Date: June 25, 2021

RE: Village Hall and Site Construction, EN2104 & EN2105– Request for information

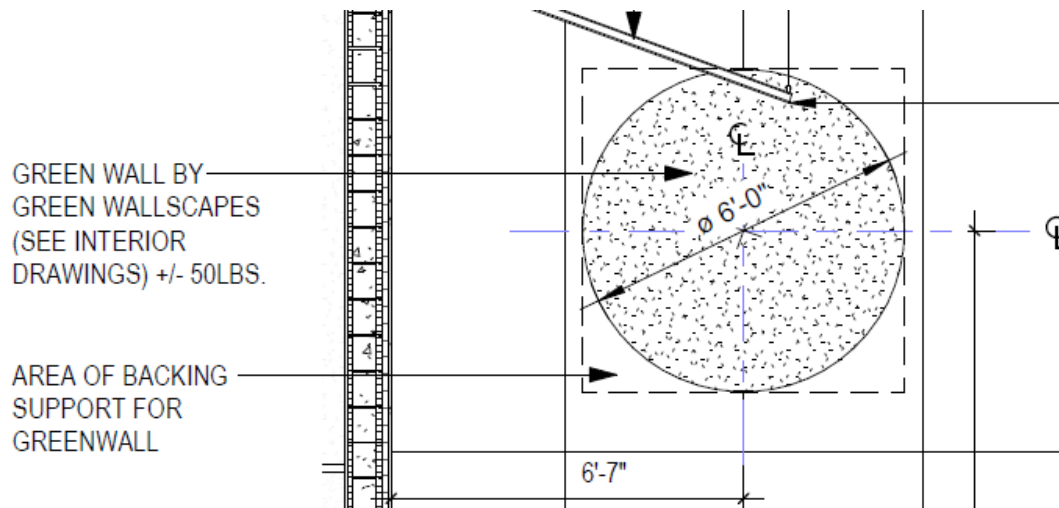
Q. Can you tell me where to find additional/detailed info on the Green Wall, details of the circled area in drawing A-4.50? it is the one with the section: 4 Main Lobby (127) Elevation 3

As stated in the drawings, the green wall feature is provided by Green Wallscapes. These items are all custom made by the company for the customer as an "art" piece. Our Interior Designer contacted the company and obtained the below quote for informational purposes. It is a 6'-0" diameter preserved moss and fern, circled-shape installation. The attached document does not constitute the final price for the item, it was obtained for informational purposes. The final piece may vary slightly in appearance from that shown in the attached picture. Bidders must contact Green Wallscapes (contact information attached in quote) for additional information regarding delivery and installation of item. Drawings call for backing behind wall in this location as we were informed that the piece can weigh up to 50 lbs.
